Infrastructure Feasibility Study

Arizona State Land Department

Union Pacific Railroad

Planning and Engineering Study

Exhibit 4 Picacho Pk

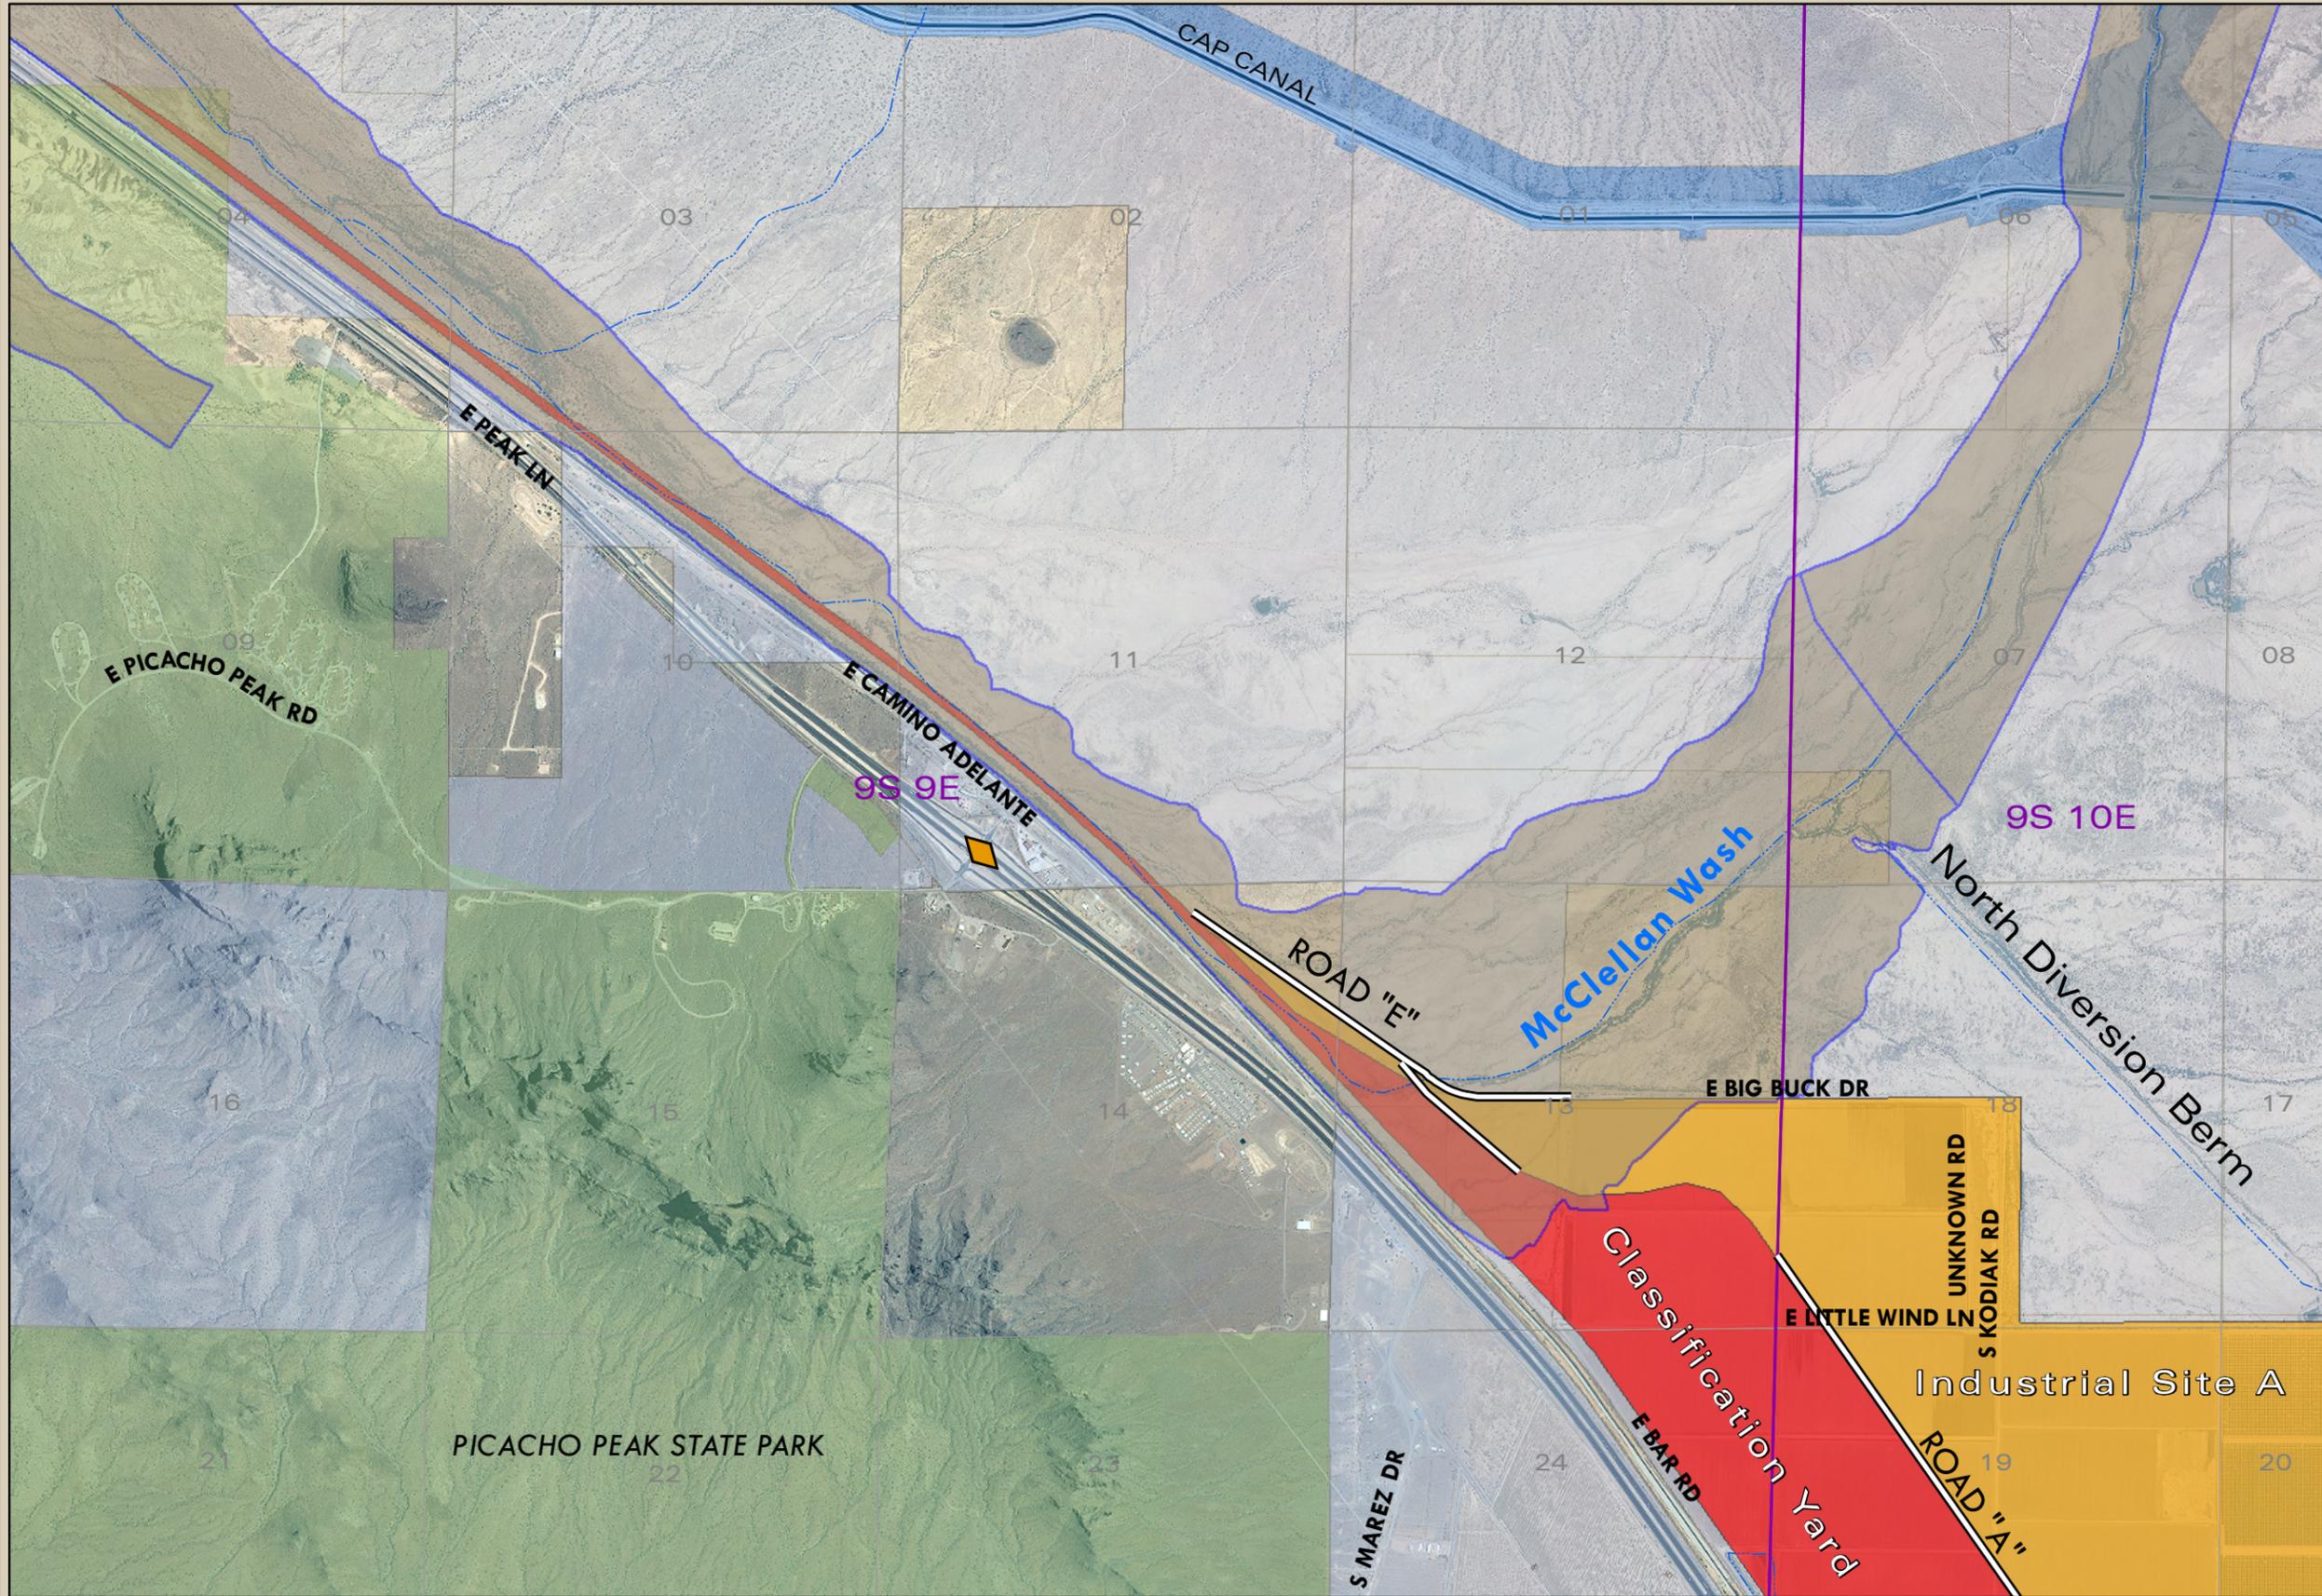
The URS Report shows a conceptual roadway within the McClellan Wash floodplain, identified as collector "Road E", from the Picacho Peak Road interchange to the east spanning 4,200 feet across McClellan Wash (See Exhibit 4). RBF's rough estimate to construct a four-lane Road E is \$55,796,707. Both the URS and RBF studies recognize Road E as proposed is not feasible and additional study is necessary to design a roadway that would provide access to State Trust Land to the north and east. If and when another study is conducted, access will still be complicated by the potential for cultural resources in the area and the need to cross both the Sunset mainline and McClellan Wash, and the Change of Access Report that would be required

Road E as proposed is not feasible and it is uncertain whether or not a feasible road can provide access to State Trust land if the classification yard moves forward.

UNION PACIFIC RAILROAD Office of Assistant Vice President Engineering Design
 LOCATION: RED ROCK CLASSIFICATION YARD RED ROCK ARIZONA
 EXHIBIT TITLE: INDUSTRIAL PARK ACCESS FIGURE 11

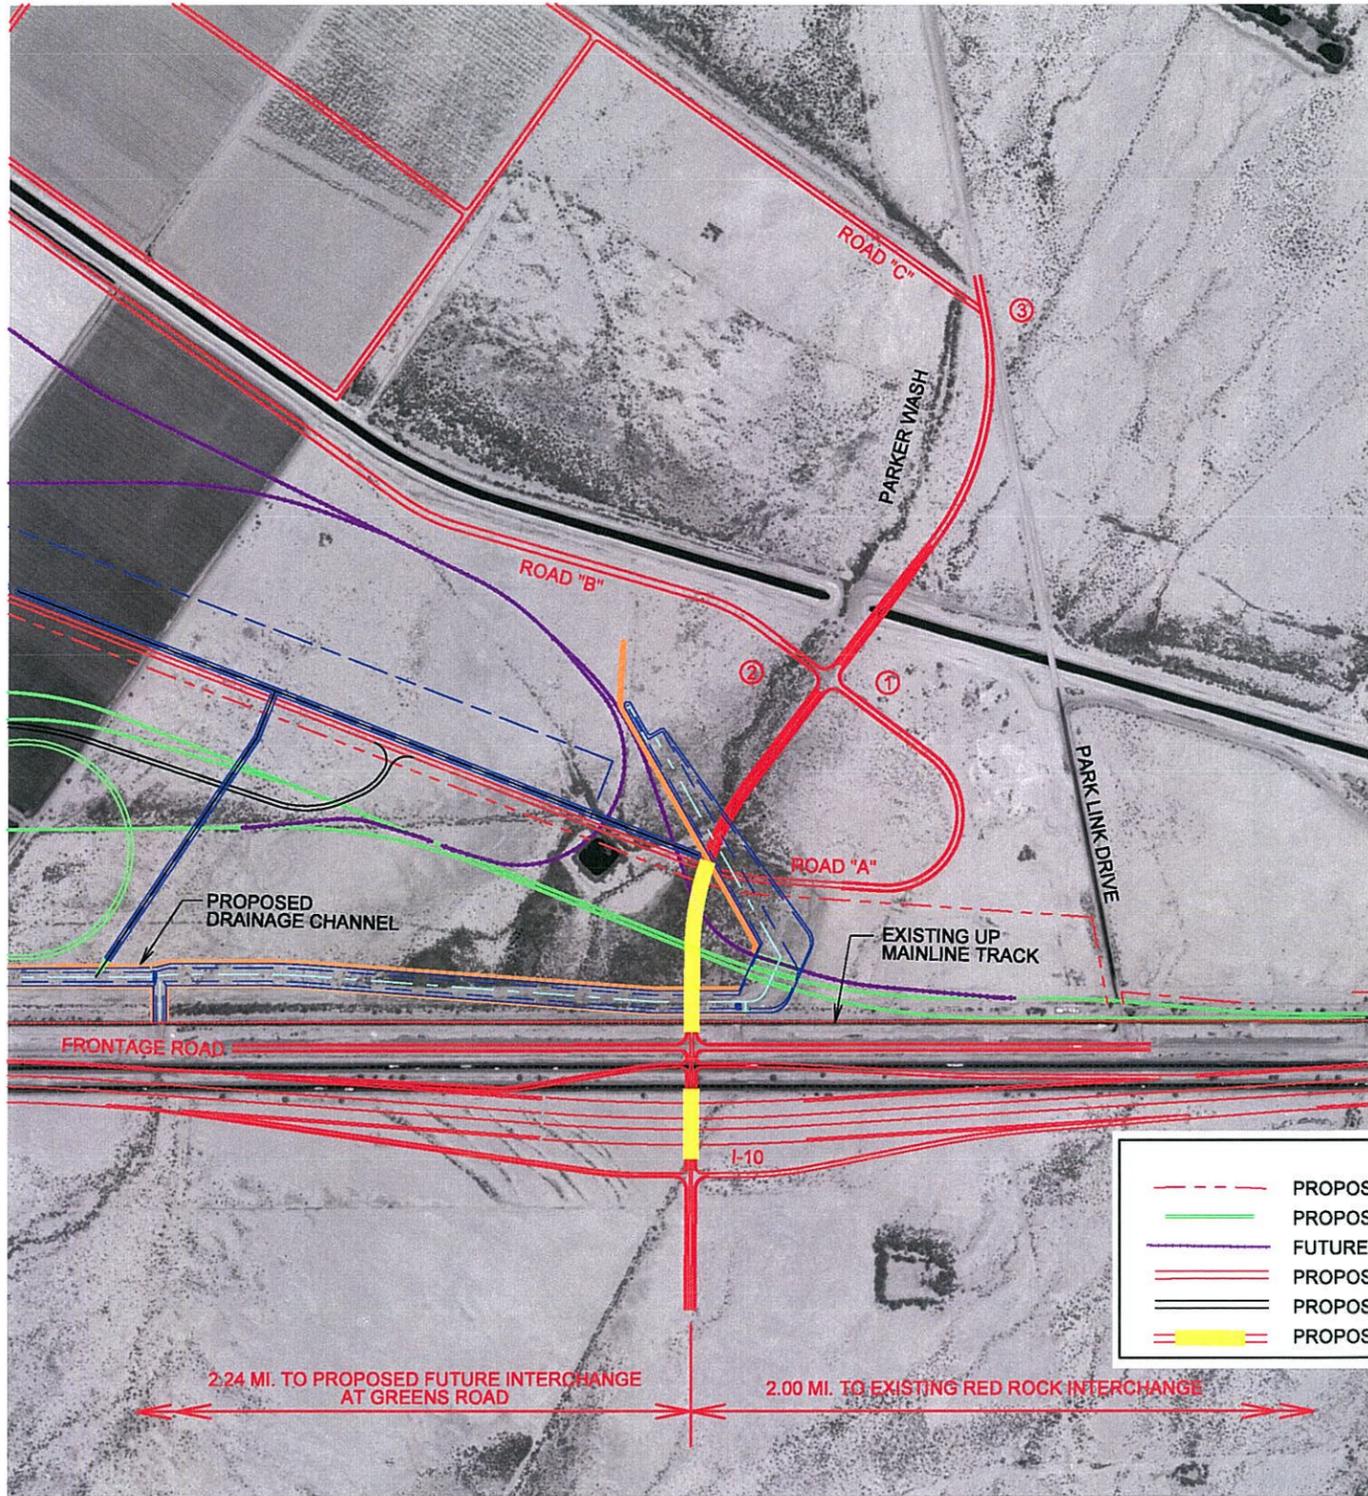
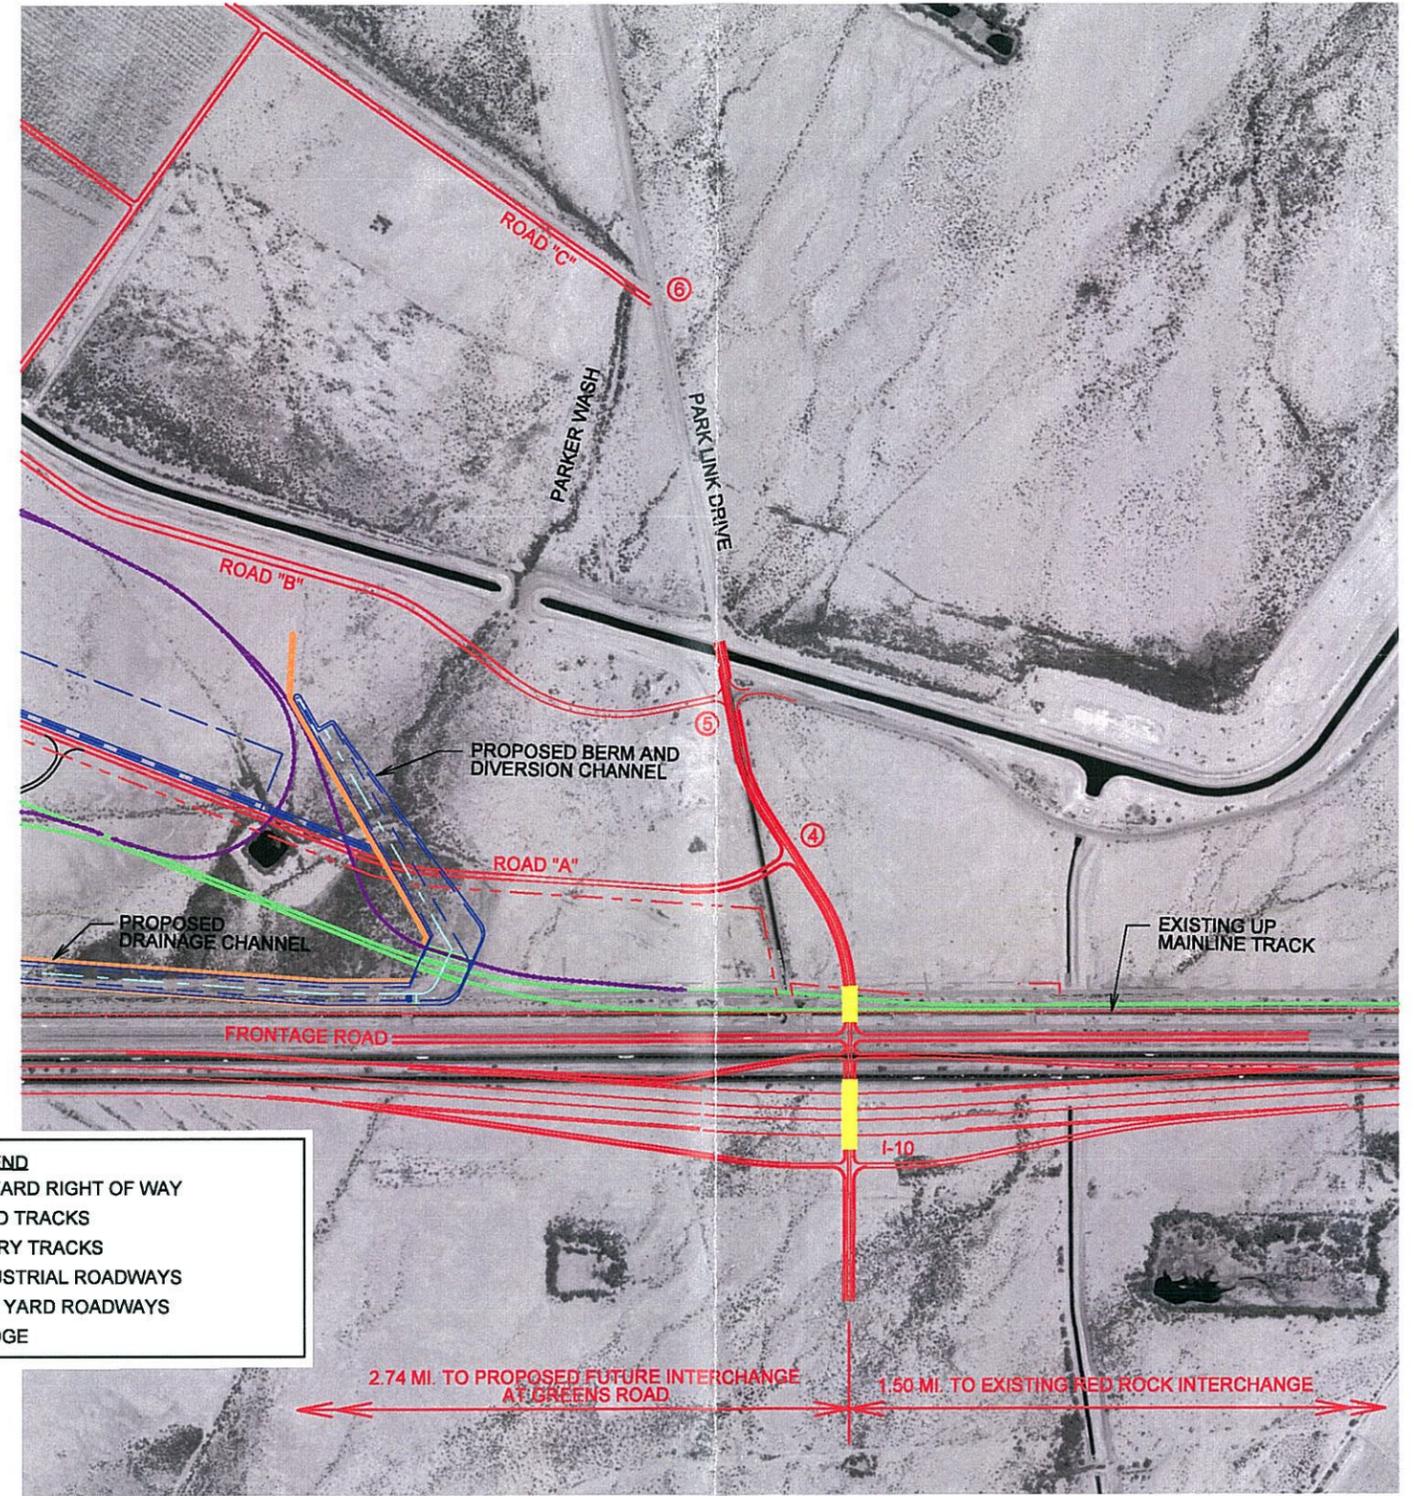
Road “E” – Please see recommendations and conclusions for detailed discussion. Road “E” is effectively intended to serve as an additional public roadway to provide access to future ASLD parcels to the north and east of the UPRR parcel and providing ultimate access to Picacho Peak Road TI. Please see Exhibit 7, Detail B for the location of Road “E”.

3. Further evaluation of the proposed roadway intersections of Road “A” and the Walton International planned access road to ensure that these two roadways create one unified 4-point intersection and not create an off-set intersection. Please refer to Exhibit 3 and Exhibit 9 which illustrate the locations of Road “A” and the Walton collector road respectively.

McCLELLAN WASH RELOCATION TYPICAL CROSS-SECTION (LOOKING DOWNSTREAM, NORTHWEST)

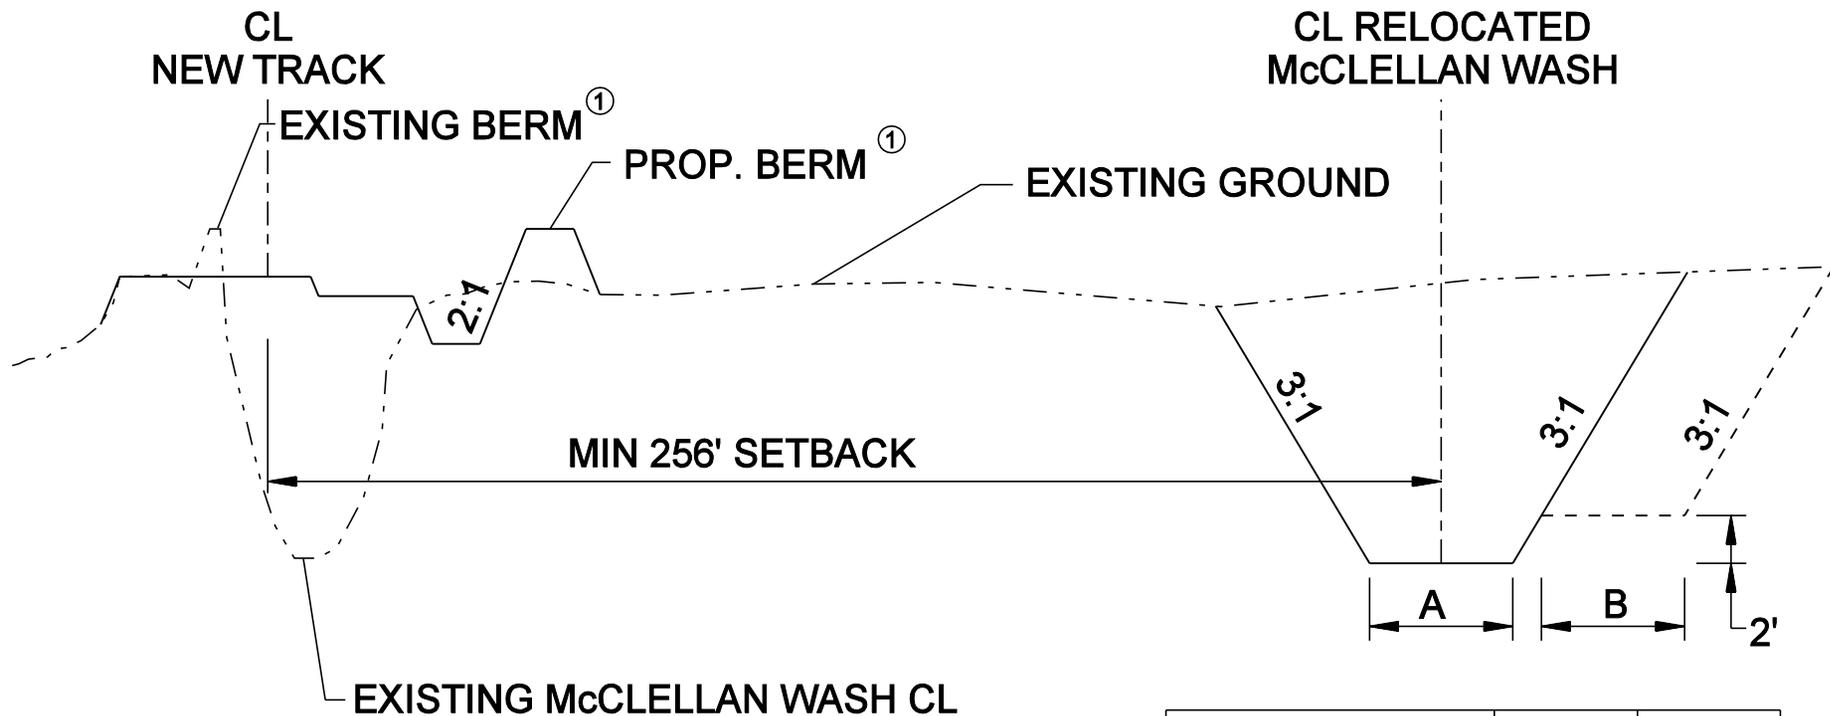
4. It is difficult to determine if the McClellan Wash proposed trapezoidal channel has 100-year capacity. If it does, why is a levee proposed at the same height as the existing levee adjacent to the railroad tracks. The detail seems to indicate the channel is below grade and the report does not explicitly state that McClellan Wash is sized to accommodate the 100-year event.
